Lemon Hall
Church Street
Hugh Town
St Mary's
TR21 0JT

Please find enclosed our representations on the latest applications for Well Cross Yard. (P-14-009-FUL, P-14-010- LBC)

Section A: Representations on Planning Application P-14-009-FUL

Section B: Representations on Listed Building Application: P-14-010-LBC

Gable End Treatment

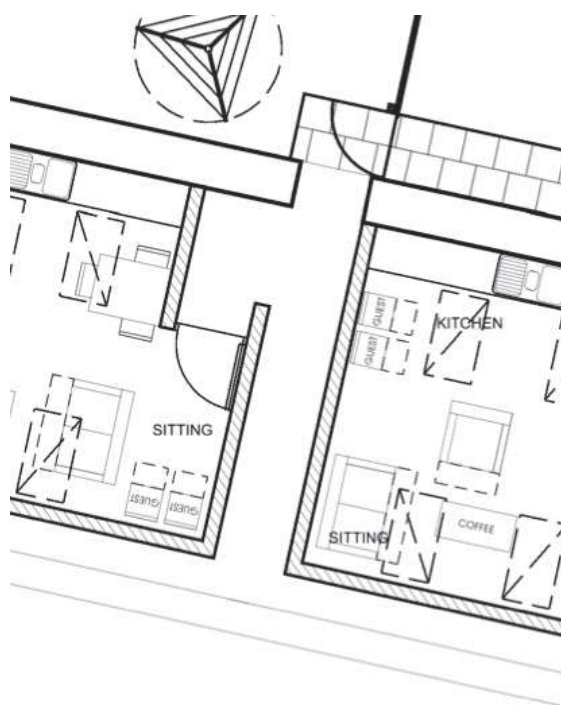
The applicant proposes to leave a single leaf breezeblock gable end wall as a permanent freestanding feature at the west of the site. This forms part of the existing shed structure and also part of the listed curtilage wall of Lemon Hall.

Leaving the gable adjacent to the new building does not protect or enhance the built environment, and we suggest it is not appropriate for any development in a conservation area to result in such an unsympathetic arrangement at completion. This is especially the case because the gable being retained is merely the infill for a semi-permanent shed structure. The council should require that the applicant find a better solution to this potential eyesore with the agreement of their neighbours.

Additionally, we are concerned about the structural safety of this gable wall, and the difficulty of maintaining it in the future, given there is only a 50cm gap between its inner face and the wall of the new building. It is currently cracked and held in place by the existing roof.

Our surveyor has advised that following removal of the applicant's roof, the gable will need to be rebuilt because it has been damaged by the roof and is

structurally unsound. When it is rebuilt, it would be more appropriate for the gable to be replaced with a flat-topped wall that matches the height of the existing walls on either side.

The Council granted planning permission in 2013 (P07/068) for a scheme that replaced the cement gable with a granite gable. In recognition of the listed status of the wall, the availability of surplus granite on the Well Cross Yard site, and the comments of the Planning Consultant in November 2013, we ask that the council places a planning condition that a replacement section of the wall be built from granite to the same height as the walls on either side.

Inadequate Maintenance Passageway

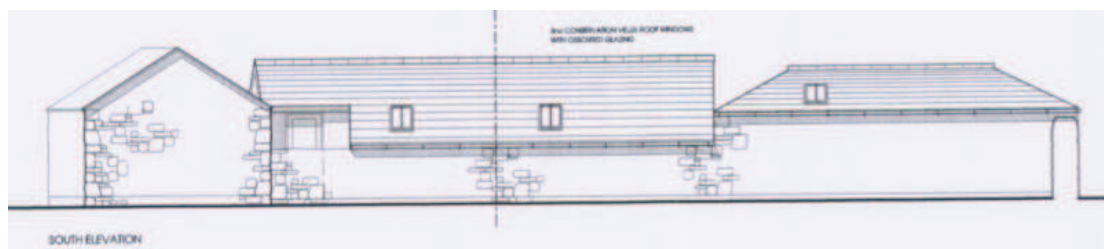
The 50cm wide maintenance passageway around the southern perimeter is too narrow for its stated purpose. Once the overhang of guttering and eaves is subtracted from this, it is not clear how the applicant will clear their gutters or

carry out roof or solar panel maintenance, without access through our garden. It is likely that debris would accumulate in this narrow passageway, where it would cause damage to the structure of the proposed dwellings and the listed curtilage wall of Lemon Hall.

We have been advised by the architect that the route around the building is not envisaged as a fire-escape, but it is not clear what other exit there is for an occupant in the corner bedroom of the two bed flat should a fire break out in the hall. The minimum width for a fire escape is 75cm for able bodied-people and 90cm for disabled people.

New proposal for the South Elevation:

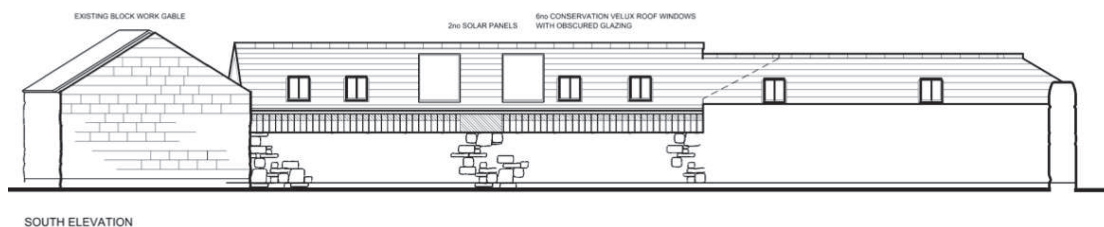
We think that doubling the number of skylights on the south elevation from three to six is excessive. It creates a much more visually intrusive façade than before and will increase our loss of privacy. The skylights are highly visible because the Well Cross proposal is single-storey.

Increasing the number of skylights would appear to be at odds with the Isles of Scilly design guide, which states *“The characteristic features of a barn, the large doorway and the limited number and small size of openings, are elements which should be respected in any conversion.”* It also specifically mentions that it is undesirable to have skylights facing each other on both sides of a ridge.

As with the previous proposal, we ask that all skylights on the south side be conditioned to be non-opening as well as obscured. This will help ensure visual privacy between Lemon Hall and Well Cross and reduce the potential for noise transfer from the new adjacent living spaces. The planning consultant who advised on the previous design, submitted 4 months ago, recommended this request be granted.

We also note that there is a clear discrepancy between the locations and width of the roof lights as drawn in the floor plan, in both the north and south elevations and also in the section drawings.

Section diagram of sight lines into the proposed living spaces:

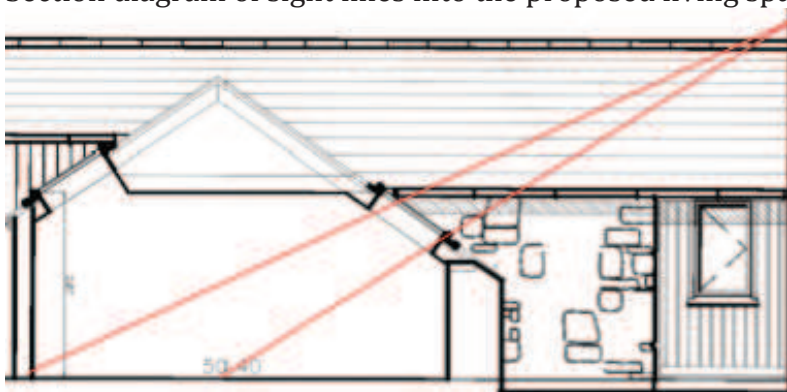
The distances between the habitable rooms of Well Cross yard and its neighbours are about a quarter of this distance. Therefore the careful siting of windows is a necessary condition for all residents. There is no evidence that the architect has considered this issue properly in the design or in the Design and Access statement.

The photo below (taken from the first floor of Lemon Hall, with the existing barns in the foreground) illustrates the proximity of the first floor flats to the proposal and the extent of the glazing that looks directly into the proposal's skylights.

Floor plan showing four proposed skylights facing the Strand:

Loss of privacy, and the creation of housing that has no privacy in its main living spaces, is a material planning concern. We suggest that the council visits the site to assess this matter as part of their decision making process.

The grey circles in the plan below show areas that are obviously inconsistent with the elevations provided.

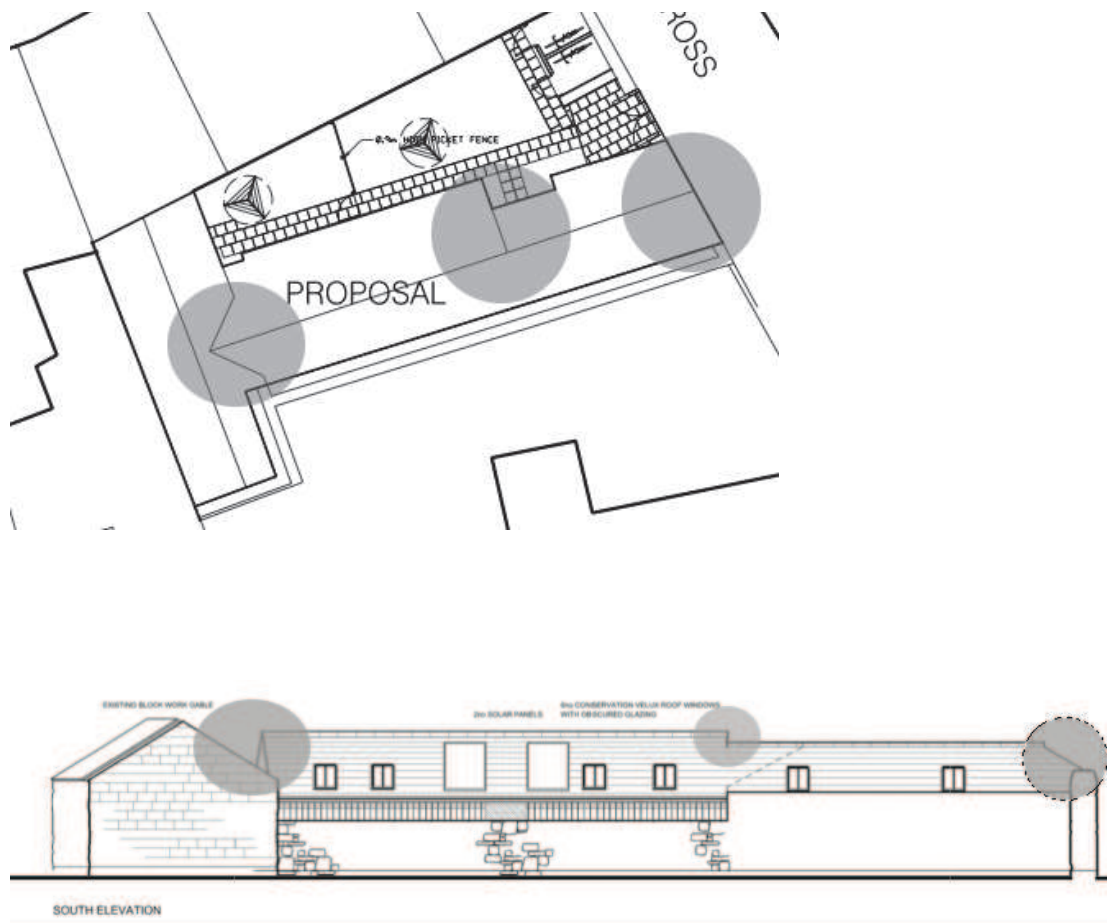
1). The most important discrepancy is the different roof structures presented in plan and elevation.

The elevation drawings show three distinctly different roof structures that broadly match the three shed structures that they replace. This gives a varied built form. By contrast, the roof design shown in the plans is a continuous monolith with two ridgelines at right angles to each other that stretch the entire length of the plot. The character of the building presented in plan would not have the same cottagey character as the previous sheds.

2). Asymmetrical roofing

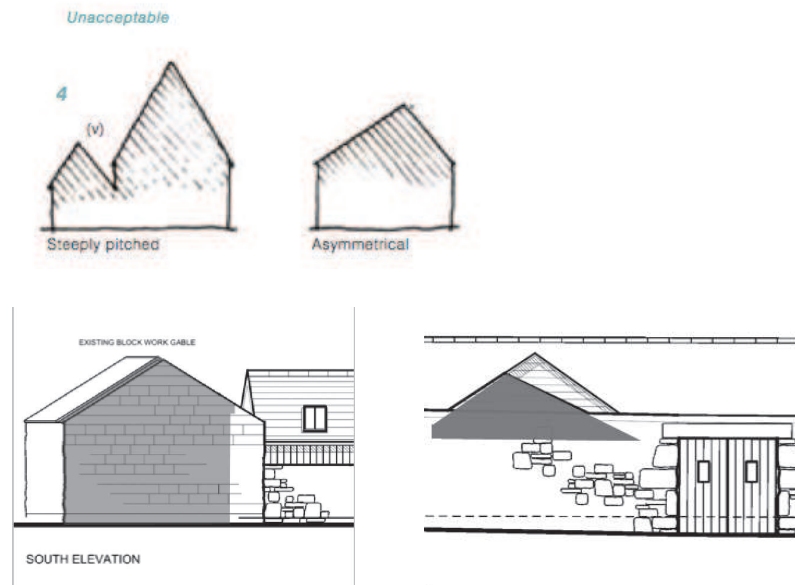
The Isles of Scilly design guide specifically refers to asymmetrical roofing as being unacceptable (see the top image below, which is taken from page 92 of the

guide). The applicant has submitted a proposal in which all three roofs proposed would be asymmetrical (shown in grey below).
